NL-04-0318

Joseph M. Farley Nuclear Plant Units 1 and 2
Application for License Renewal –
January 22, 2004 and February 3, 2004 Requests for Additional Information

Joseph M. Farley Nuclear Plant Units 1 and 2
Application for License Renewal-
Responses to January 22, 2004 and February 3, 2004
Requests for Additional Information

RAI 4.3.4-1c

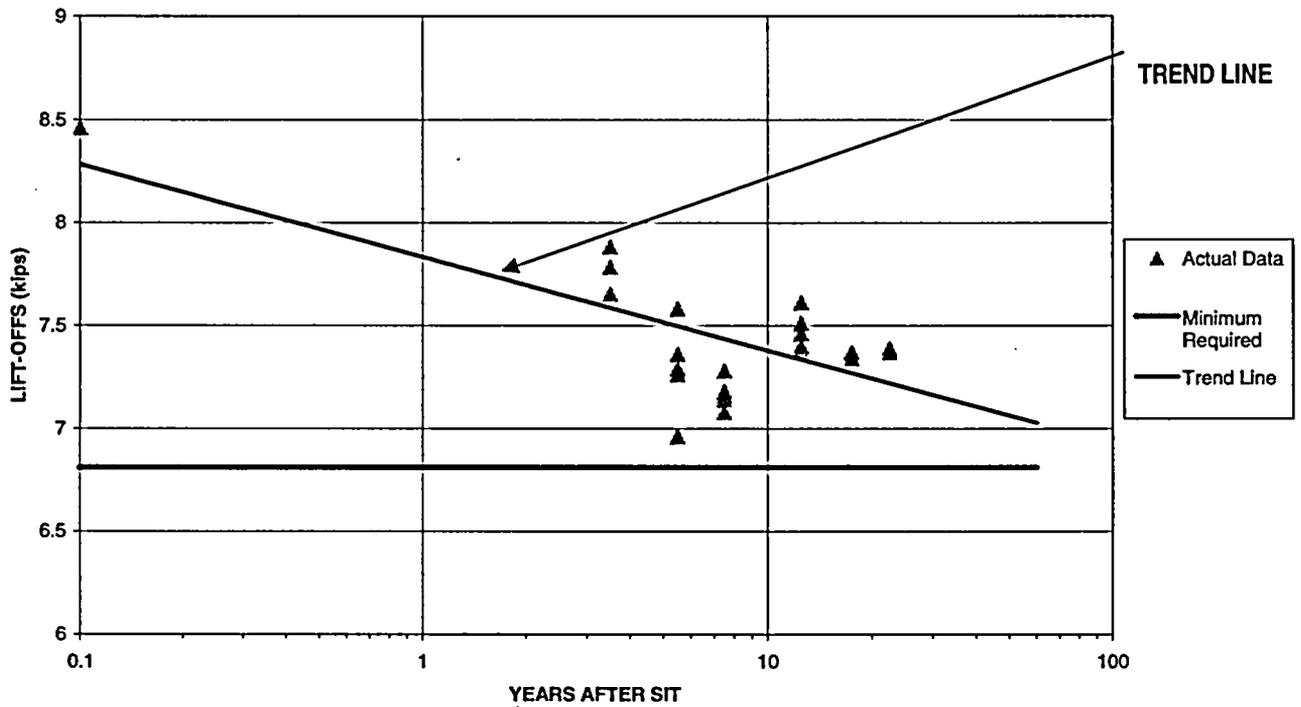
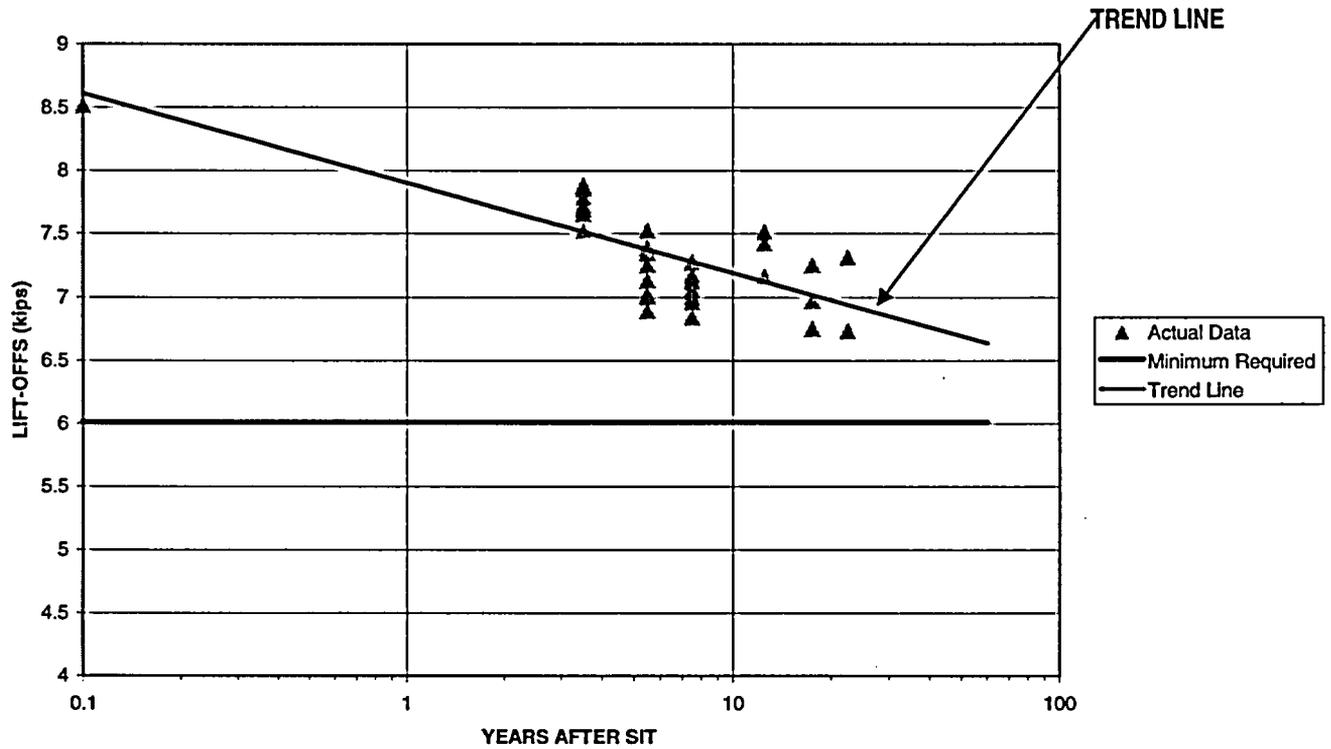
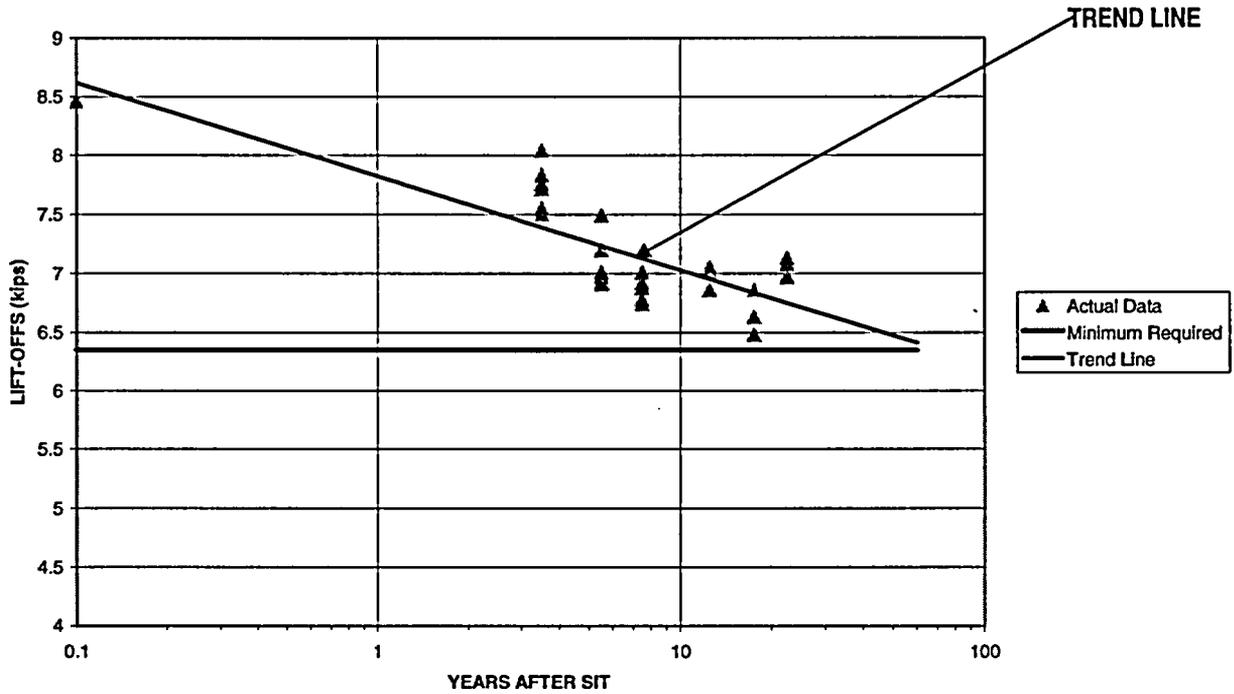
10CFR54.21(c)(1)(ii) requires that the applicant demonstrate the adequacy of the analysis projected for the extended period of operation. In order for the staff to make a reasonable assurance conclusion, the applicant is requested to provide the following information:

- (c) Plots showing comparisons of prestressing forces projected to the end of the extended period of operation with the minimum required prestress for each group of tendons.

UNIT 1 VERTICAL TENDONS
ACTUAL FORCE TREND
(from past 6 surveillances)

UNIT 1 HOOP TENDONS
ACTUAL FORCE TREND
(from past 6 surveillances)

UNIT 1 DOME TENDONS
ACTUAL FORCE TREND
(from past 6 surveillances)
